| 10-2016 LATEST REVISION DATE | APPROVED BY BRIDGE ENGINEER | STANDARD DESIGN - 40' ROADWAY, 3 SPAN BRIDGES ROLLED STEEL BEAM BRIDGES JUNE, 2010 | |
| | | FRAMING PLAN 160'-0" BRIDGE | RS40-041-10 |

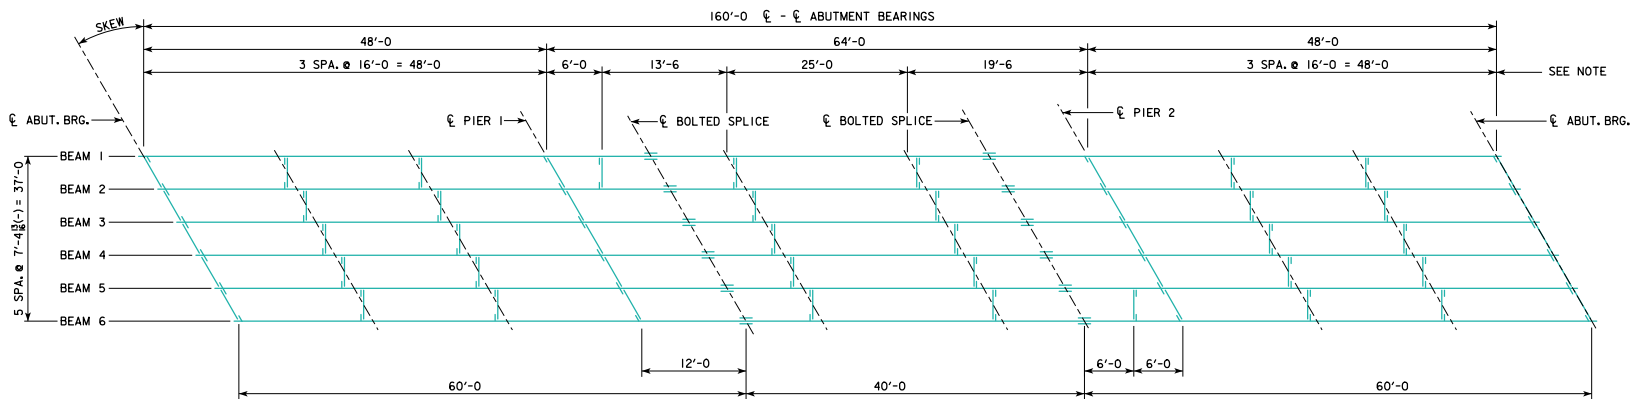
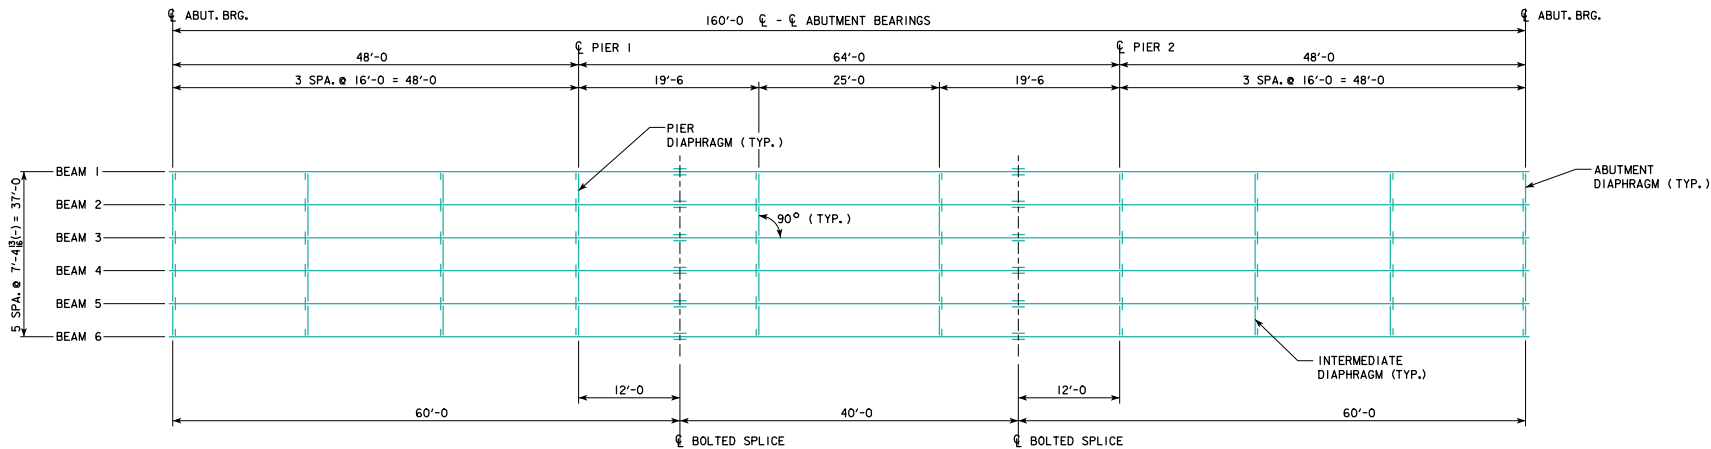
REV/ISED 10-2016 -- ADDED DIAPHRAGMS TO SKEWED FRAMING PLAN IN OUTER BAYS, BETWEEN BEAMS 1 & 2 AND 5 & 6 OF 64'-0" CENTER SPAN, 6'-0" FROM PIER CENTERLINES.
